Permit To Take Water No. 1381-95ATPY for Triton Water
Canada Holdings, Inc. for bottling water purposes

RE: Report ADM-2021-042 Triton Water Permit to Take Water Renewal

SUBJECT: Triton Water Canada Holdings, Inc. (formerly Nestle Canada) Permit to Take Water Application

Response to Harden Comment 1 con't

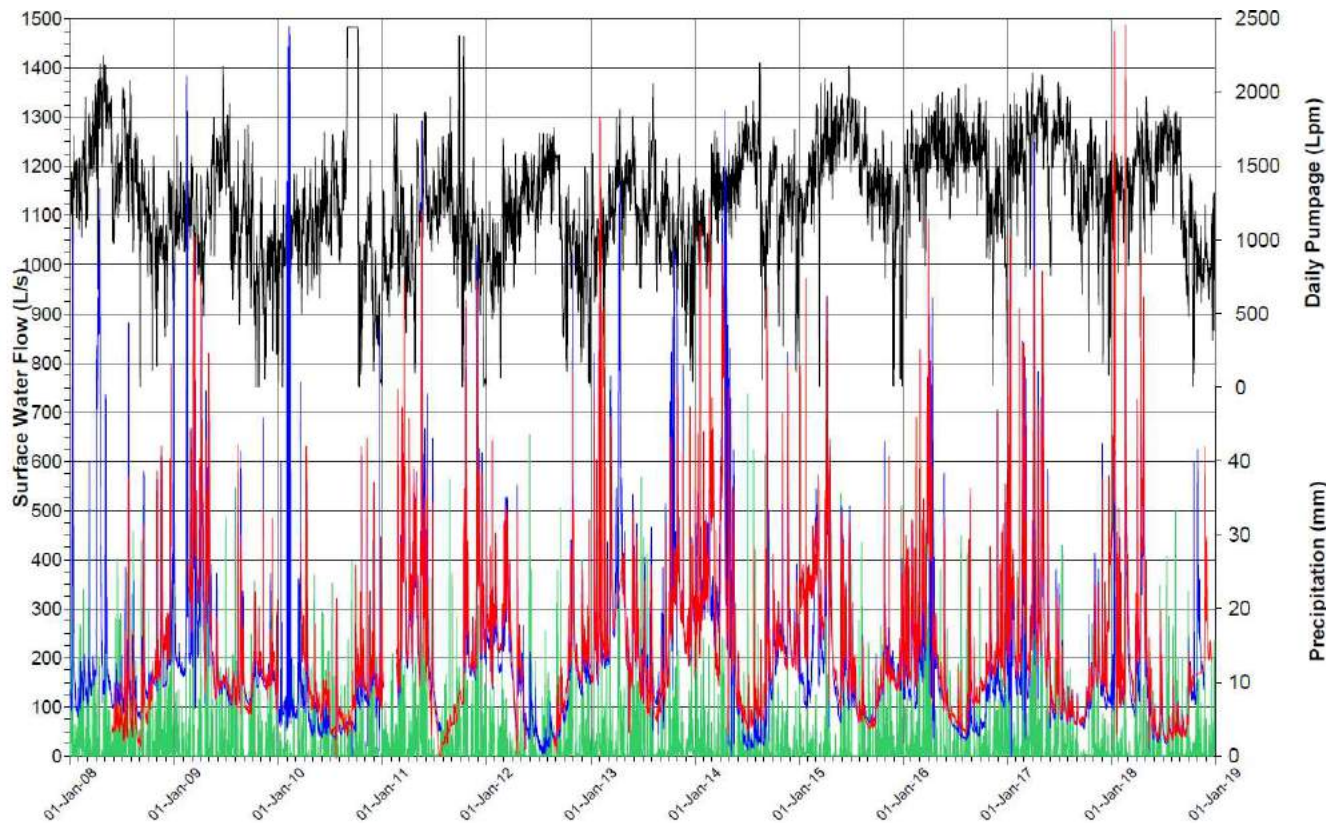
Comment 1 – the manual flow measurements at SW2 are sometimes lower than the flow measurements at SW2 estimated using the stage-discharge rating curve.

- This is due to the following:
 - The channel cross-section at SW2 can vary from year to year (and can be impacted from stream rehabilitation).
 - The irregularity of the coarse bed materials introduces error to both the measurement of depths across the channel and velocity in proximity to the bed.
 - Flow through the coarse substrate, known as gauge underflow, is likely occurring at SW2. The magnitude of gauge underflow and the error it introduces cannot be measured using standard stream flow measurement techniques, but the error is larger for shallow depths of flow and less significant for greater depths of flow.
 - A change in barometric pressure data at the end of the year may have caused an overestimation of water level and flow at both SW1 and SW2. The water level error is very small but the change in flow is more significant.

- In order to provide a continuous record of flow, the rating curve is used to estimate flow.
- Rating curve is adjusted each year to account for changing stream conditions based on two scenarios:
 - A simple re-fitting of the curve to include additional data when the cross section has not changed measurably; or
 - Development of a new rating curve to reflect changed cross section geometry (requires new data and improves with time).
- More weight is placed on the higher flow measurements to account for difficulty in measuring shallow flows and gauge underflow losses.
- Likely results in a better estimate of total flow.
- Stream flow measurements and rating curves were developed using industry standard methods.

**HYDROGRAPHS FOR WELLS INSTALLED IN OVERBURDEN - D
SUPPLEMENTAL HYDROGEOLOGIC INVESTIGATION
NESTLÉ WATERS CANADA**

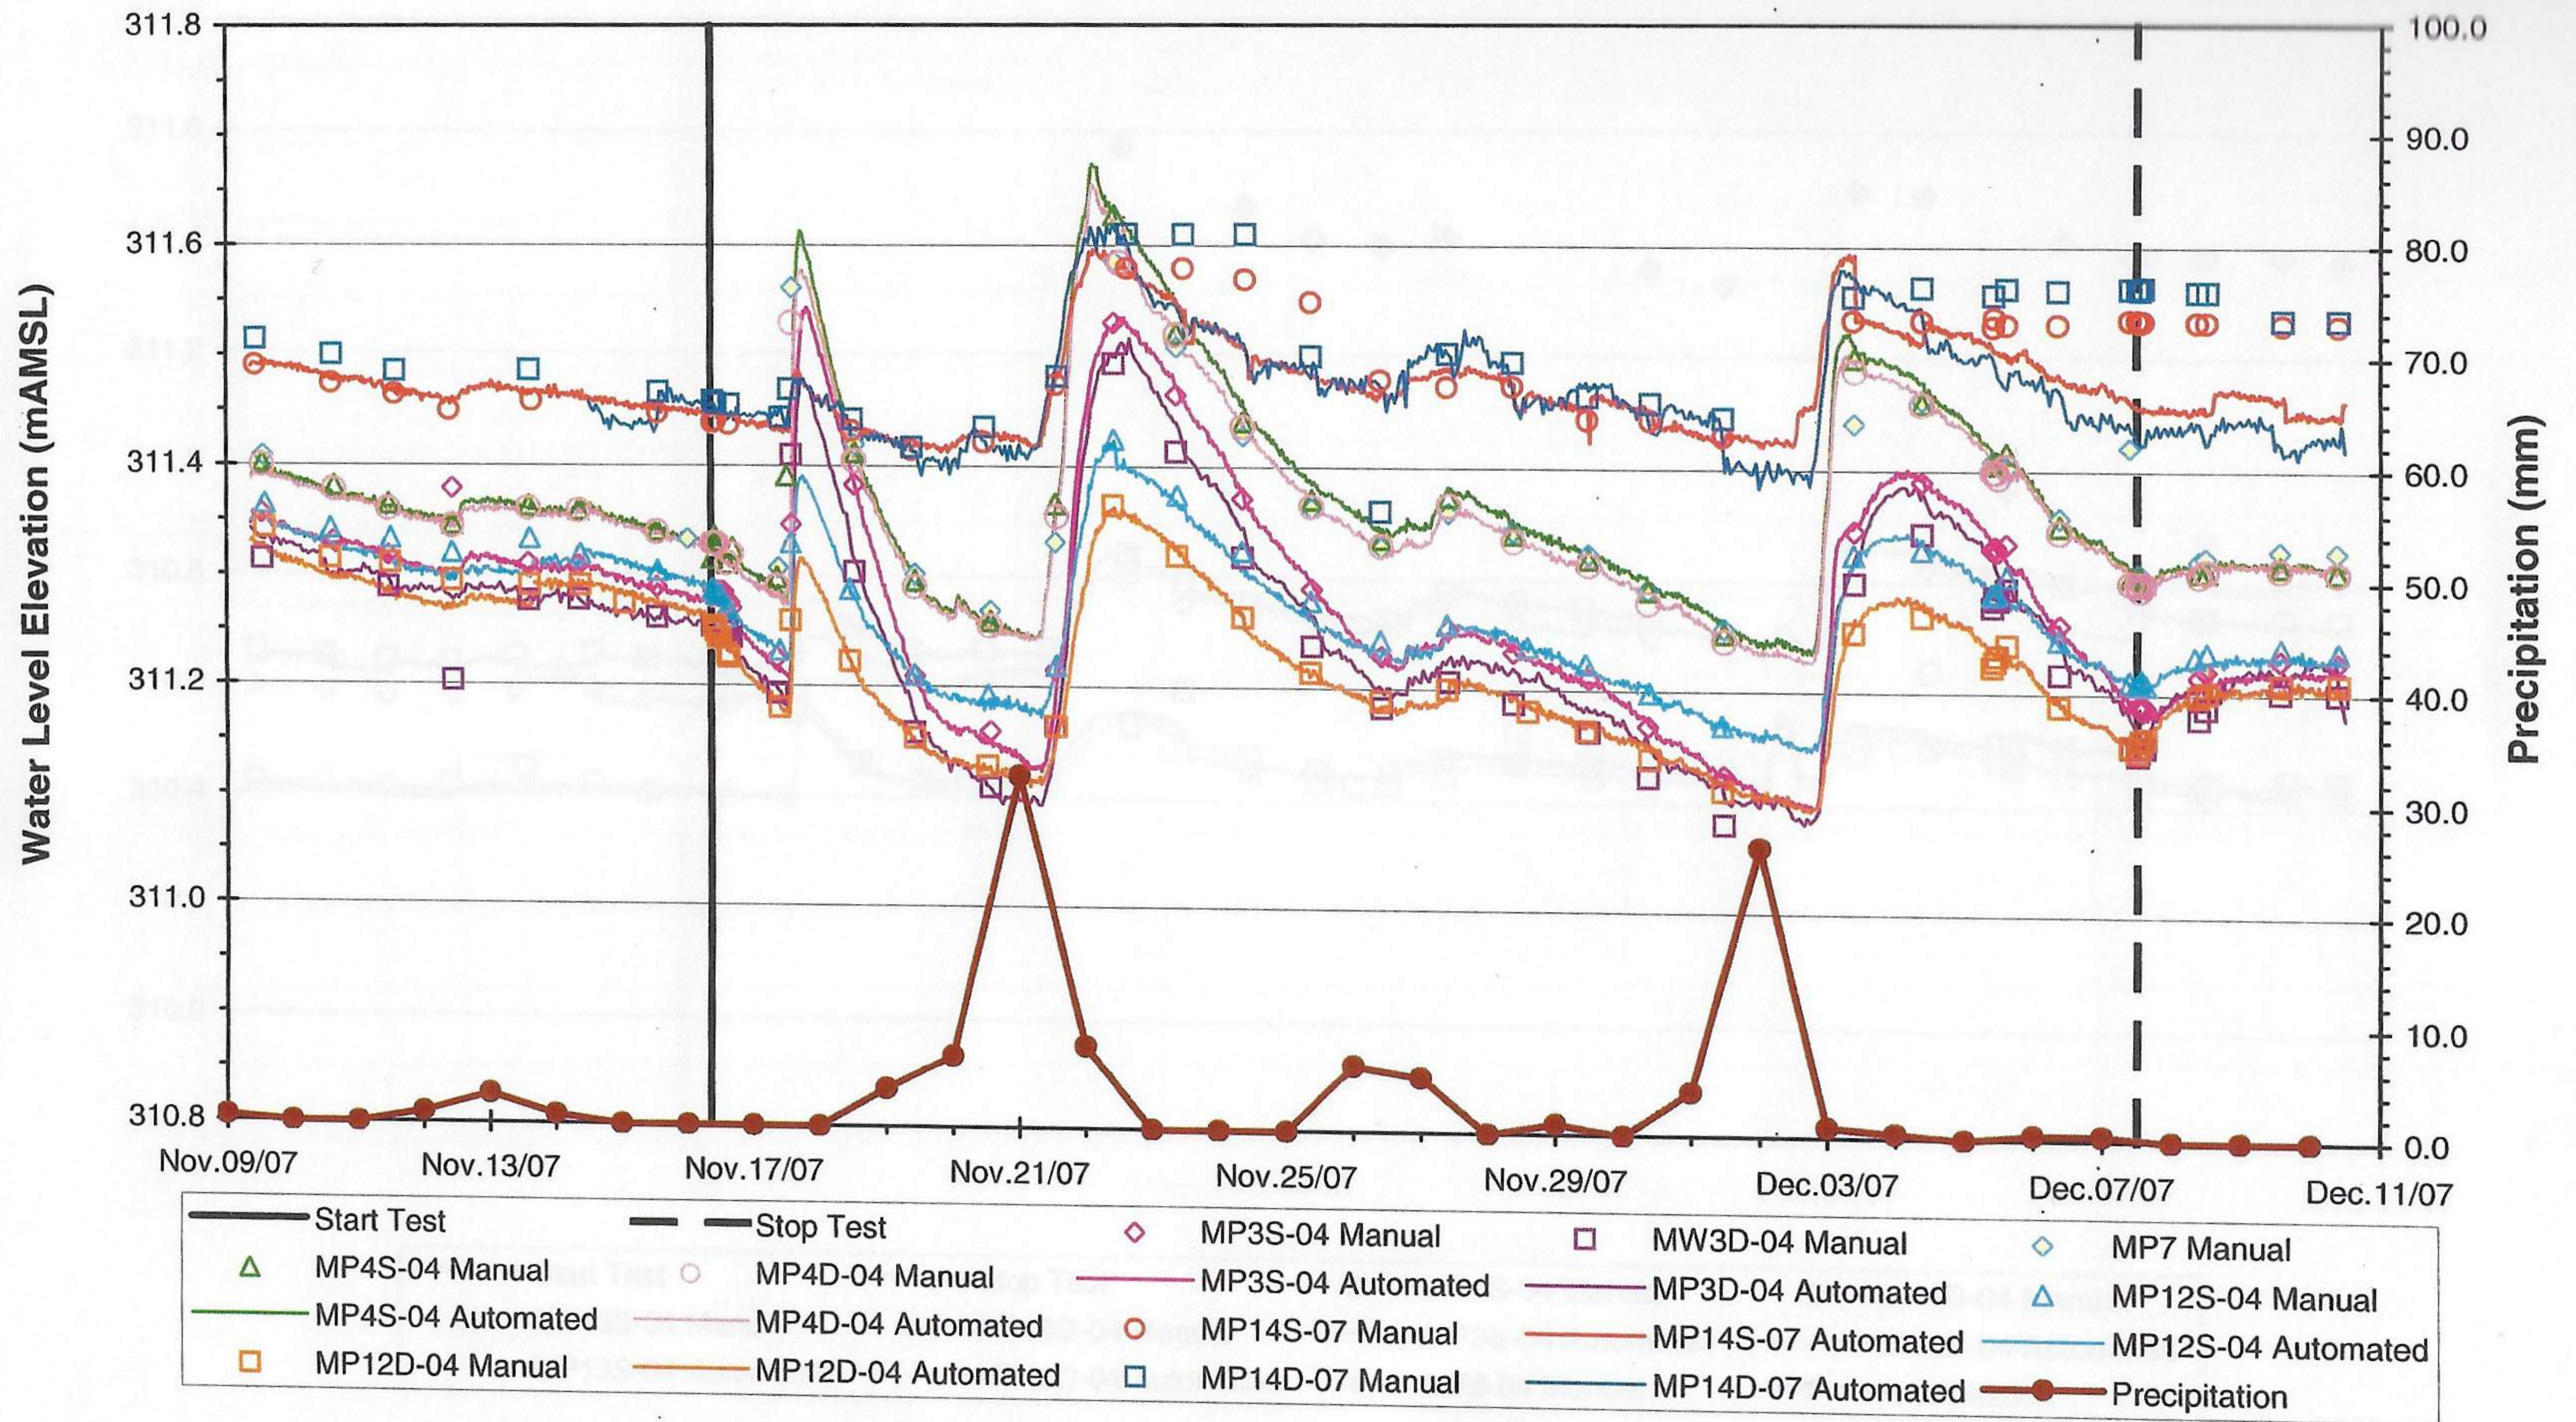
For example, in 2020, overburden wells MW4C and TW1-99 both show a decrease in water levels as the pumping increases and but water levels then do not recover as the pumping rates decrease. This is a different response than observed in the bedrock wells and the delayed recovery is due to a lack of water to support the recovery, i.e. recharge.

PROJECT NO. 13-1152-0250 (1000) REV A FIGURE F3b

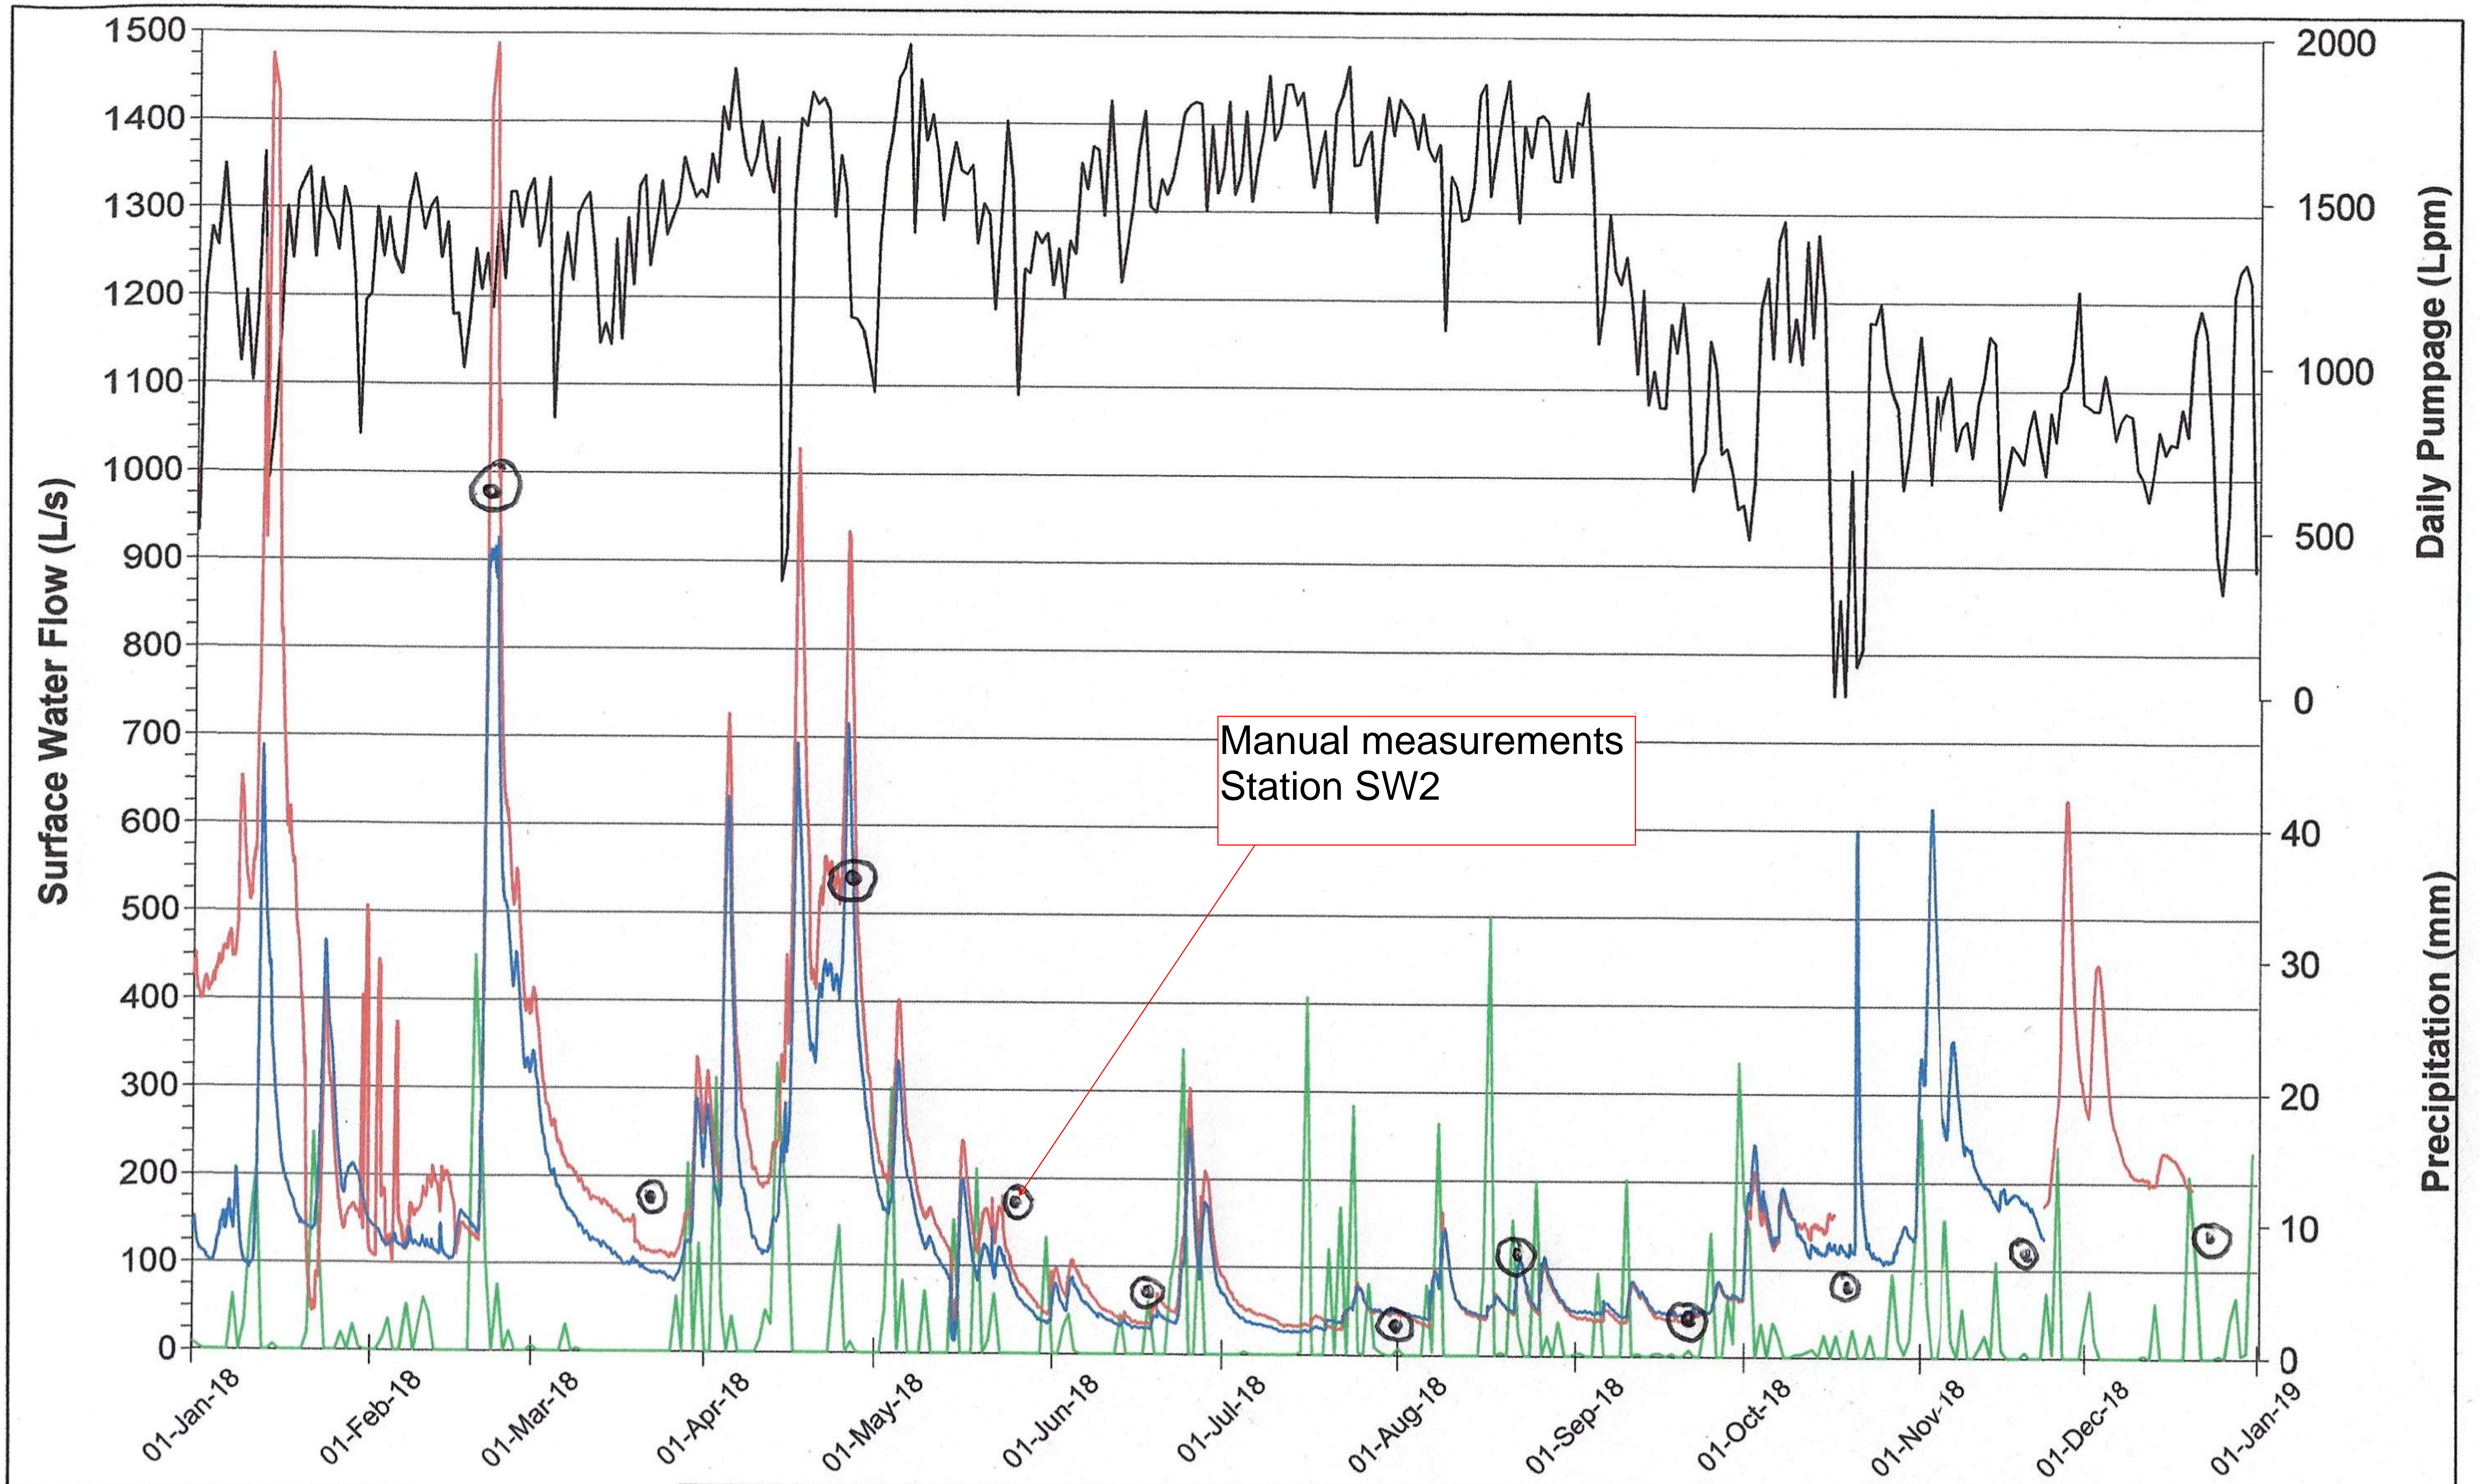
The simulated continuous (Figure F3b) flow graph developed from the stage-discharge relationship does not reflect the measured conditions accurately in 2020.

The simulated surface water flow graph F3b shows that there are higher flows at SW2 throughout the 2020 summer in comparison to SW1. In some instances, there is significantly greater flow downstream than upstream. Clearly the stage-discharge graph for 2020 does not accurately represent manual stream flow measurements and brings into question the purpose of stage discharge figure F3b. The critical period of streamflow with respect to ecological function is low flow. Therefore, representing the low flow periods accurately between manual measurements is important as the data loggers are intended to be a surrogate for other more manually intensive monitoring methods. That is to say, if the data logger data cannot be used to accurately represent streamflow on days when measured, then it should not be relied upon to represent flow conditions in the stream at other periods of time. We have reviewed additional explanations of the low flow observed at SW2 (See Appendix ____). We do not agree that the simulated hydrograph is a better representation of flow than the manual measurements. Manual measurements conducted by Mill Creek Aggregates corroborate low flow conditions in Mill Creek at the same time as recorded at SW2. The discharge rate measured is lower than that simulated for SW2 presented on Figure F3b. Our position is that if the stream is not gaining for increasing periods of time due to droughty conditions and it is known that the hydraulic properties of the Upper Bedrock Aquitard, Upper Bedrock Aquifer and the overburden allow effects of pumping to propagate upward, then there should be a

The difference between the 2020 field measured streamflow values and streamflow values determined from the stage-discharge relationship is significant, particularly during low flow conditions. Not only do the calculated (via Stage Discharge relationship) 2020 flows show that there is an increase in surface water flow under all conditions between SW1 and SW2, the flow rate suggested by the continuous flow graph is several times greater than that measured. In order for stage, measured by transducers, to be a reliable method of determining stream flow, an improved stage-discharge relationship must be used.

We have added the measured streamflow for station SWM1 at the Mill Creek Aggregates site to the continuous discharge graph prepared by Golder (2021). These measured values of streamflow are from a location 2.5 kilometers downstream of the Blue Triton site and downstream of the confluence with Mill Creek. Even at that distant location, the measured streamflow values are lower than the calculated values presented in Golder (2021). This shows that there is a significant overestimation of streamflow in Figure F3b (Golder, 2021)

Figure 1: Piper Plot: Nestle Waters Canada

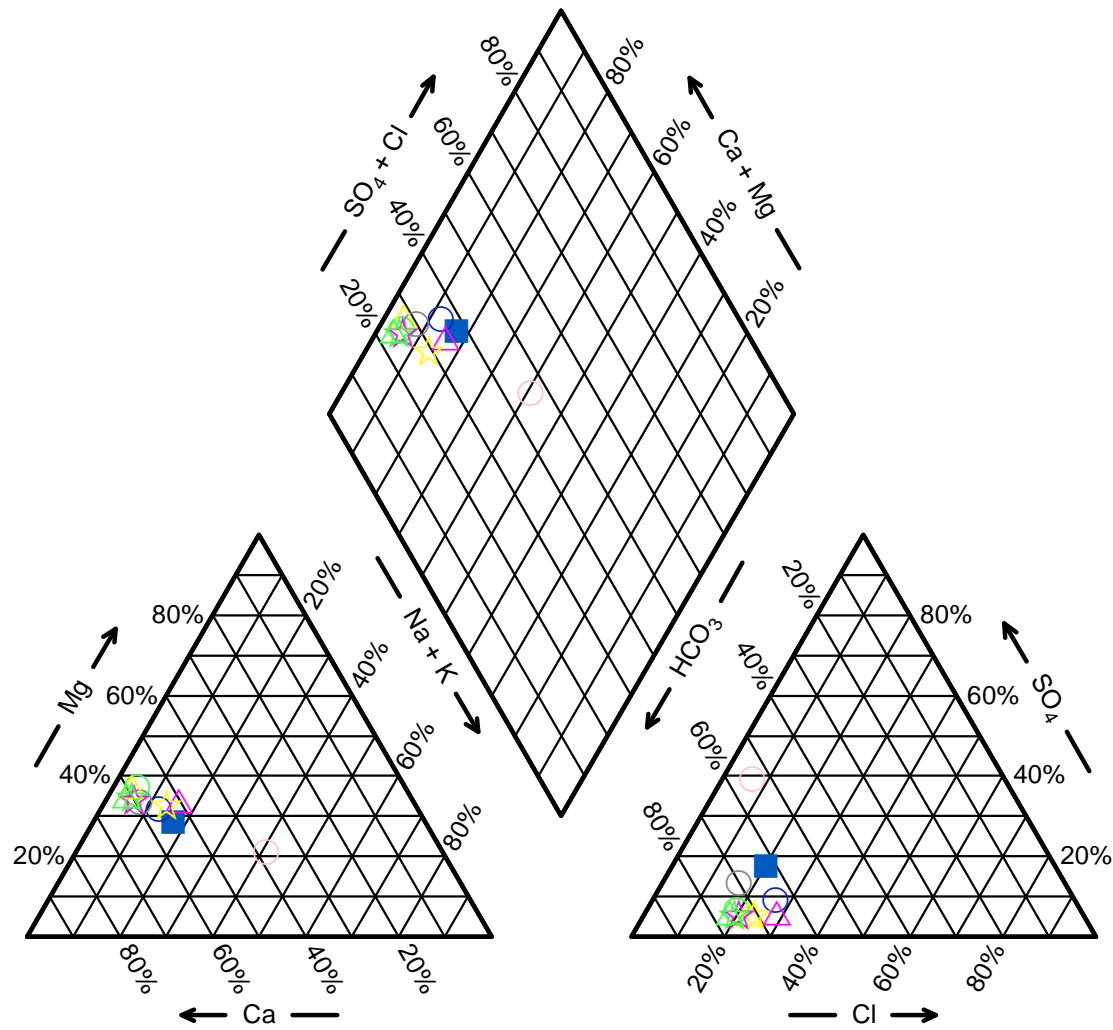
There is already chemical evidence of the influence of the Guelph Formation and overburden derived groundwater on water in TW3-80. In September and December 2007 water samples were obtained from several wells on the NWC property at 101 Brock Road. In December 2009 samples were obtained from groundwater monitoring wells at the nearby NWC property located at 46 Gilmour Road. The samples obtained in 2009 were obtained from specific formations and provide a chemical signature of water from the Guelph, Goat Island and Gasport Formations. The main cations and anions of samples obtained in 2007 and 2009 are summarized in Table 2 and presented as a piper plot on Figure 1.

Our conclusion from the water quality data is that water taken by Nestlé Waters Canada has a significant component of shallow formation water. There is no other reasonable explanation for the elevated concentration of chloride. It is our opinion that the water quality data challenges the assertion by CRA that the Gasport or Goat Island Formations are the major source of water for well TW3-80 and challenges the CRA assertion that the Eramosa Formation is an effective aquitard. The implication of this is that shallow water sources contribute to production well TW3-80 to a greater degree than suggested.
